APPENDIX B – PERTINENT CORRESPONDENCE

TABLE B-2. SUMMARY OF CORRESPONDENCE FROM STATE, AGENCY, AND PUBLIC REVIEW OF THE ENVIRONMENTAL ASSESSMENT AND PROPOSED FINDING OF NO SIGNIFICANT IMPACT.

Stage Hydrograph of S-190 Headwater and Tailwater in relation to gage 3A-NW and 3A-SW-B. Please reference comment 12 above.

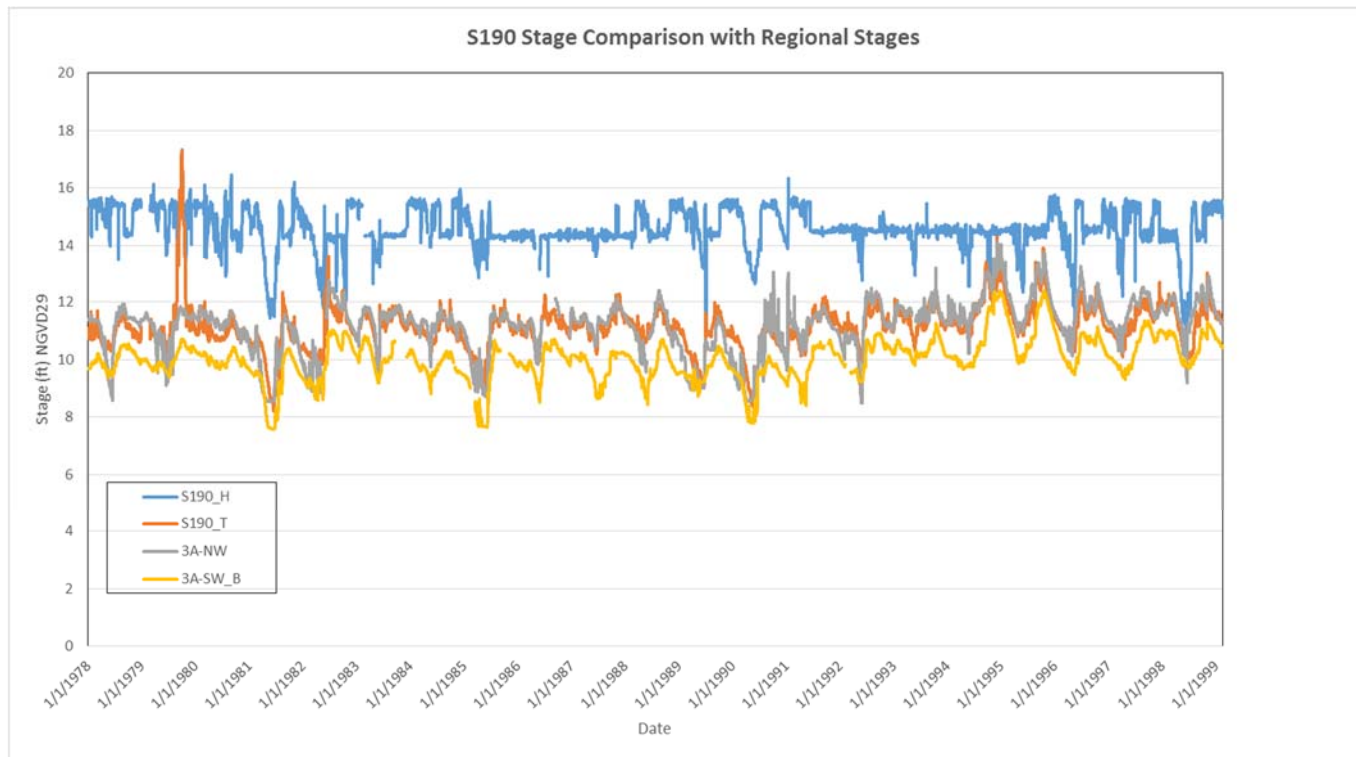
Comment Number	Commenter	Comment	Response
		Alternative) of the Final EA. The EPA recommend the USACE expand their discussion to include advantages and disadvantages of Alternative 2 (versus Alternatives 3 and 4) and quantify the disadvantages of the pre-storm drawdowns of Alternative 3 and 4.	3, 4, and 5 include the potential operating range of 14.8 to 14.2 ft NGVD to be used in anticipation of a large rainfall event, which may result in a potential loss of groundwater during pre-storm drawdowns. Text has been added to Section 2.4 to reflect the above. The Seminole Tribe identified Alternative 2 as the Preferred Alternative.
11	FWC October 14, 2016	The FWC has fish and wildlife and land management responsibilities for WCAs 2 and 3, which are managed as the Everglades and Francis S. Taylor Wildlife Management Area. Therefore, potential impacts to WCA 3A are the focus of this review. After review of the modeling documentation, it was determined that only gauges north of I-75 were used in the analysis: 3A-NW and 3AN1-GW1. Please note that this area is north of the outflow of the L-28 Interceptor Canal which receives flow from the S-190. Considering that the normal flow of water in WCA 3A is generally from northwest to southeast, an analysis using gauges south of the L-28 Interceptor Canal terminus, such as 3A-SW-B, may provide additional beneficial information. Gauge 3A-SW-B is located in an area where surface waters are more likely to be impacted by modifications of the S-190 operational schedule. FWC staff recommends that the U.S. Army Corps of Engineers considers providing additional information on the specific gauge selections in WCA 3A or considers additional analyses using gauges where surface waters	The purpose of the comparative analysis of S-190 head and tail water stage data with selected stage monitoring gauges in Big Cypress National Preserve (BCNP) and Water Conservation Area 3 (WCA 3), particularly 3A-NW, BCNPA1, BCNPA2 and BCNPA12, was to determine to what extent the proposed S-190 headwater operating criteria in the wet season might impact regional water levels in these areas. Due to the lack of an integrated hydrologic analysis tool, historical data was used to investigate what correlation exists between S-190 operations and regional water level trends. Based on the information presented in the report, it is apparent that the tail water at S-190 follows the regional water level trends observed in the monitoring gauges selected. This data set also showed that the water levels in BCNP and WCA3 A are

Comment Number	Commenter	Comment	Response
		are more likely to be affected by the proposed operational changes.	less influenced by the operations of S-190. In addition to the information provided, the FWC recommended an evaluation of the 3A-SW-B gauge. This gage was plotted along with the S-190 head and tail water stages for comparison purposes. See figure below. It can be seen from the resulting stage hydrographs that although the S-190 operations varied during this period, the tail water stage at the structure followed the regional trend observed in 3A-SW-B which in turn followed a similar trend as those monitoring gauges originally included in the report. Therefore, based on the stage hydrographs for 3A-SW-B, it can be inferred that regardless of the operation of the S-190 structure, its effect on the regional system is negligible as indicated by the similar behavior of the 3A-NW and 3A-SW-B gauges which are typical representations of the regional system.
